9 Mile PD Amendment/Minor Subdivision Public Hearing Notice

Memo

Public and Infrastructure Plans Comments – 2nd Submittal

INFRASTRUCTURE CONSTRUCTION
DOCUMENTS
NINE MILE CORNER
EVERGREEN DEVCO INC

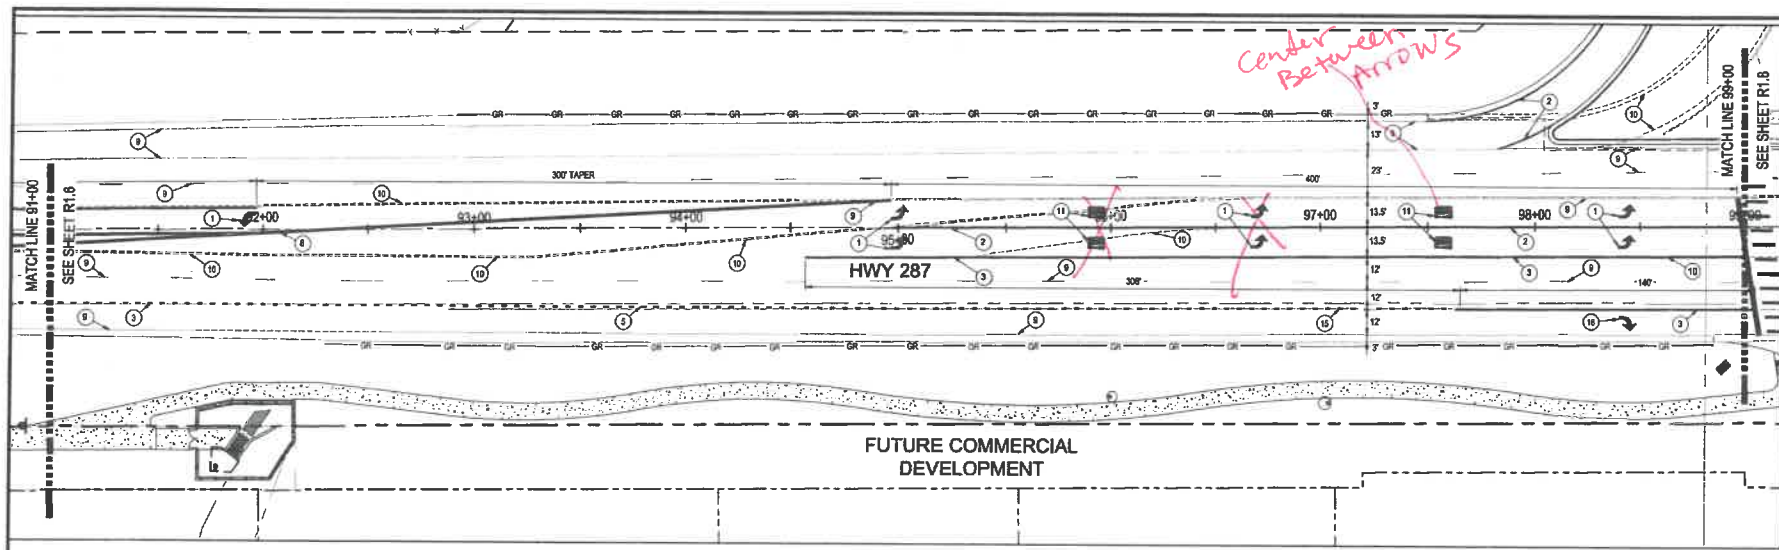
Their pavement design does not appear to be of sufficient thickness under their current design methodology, and needs to be designed in Pavement ME, especially the HMA sections on HWY 7 and 287. We may consider installing the concrete to existing thickness in the intersection, but their HMA appears very thin in their geotech report. I do not know how familiar this company is with Pavement ME but they should be notified they will need to use CDOT's Pavement Design Manual and use CDOT's database information for HMA mixes and all CDOT calibration coefficients for the program.

After they complete their design they will need to identify exactly which types of HMA mixes are to be utilized also.
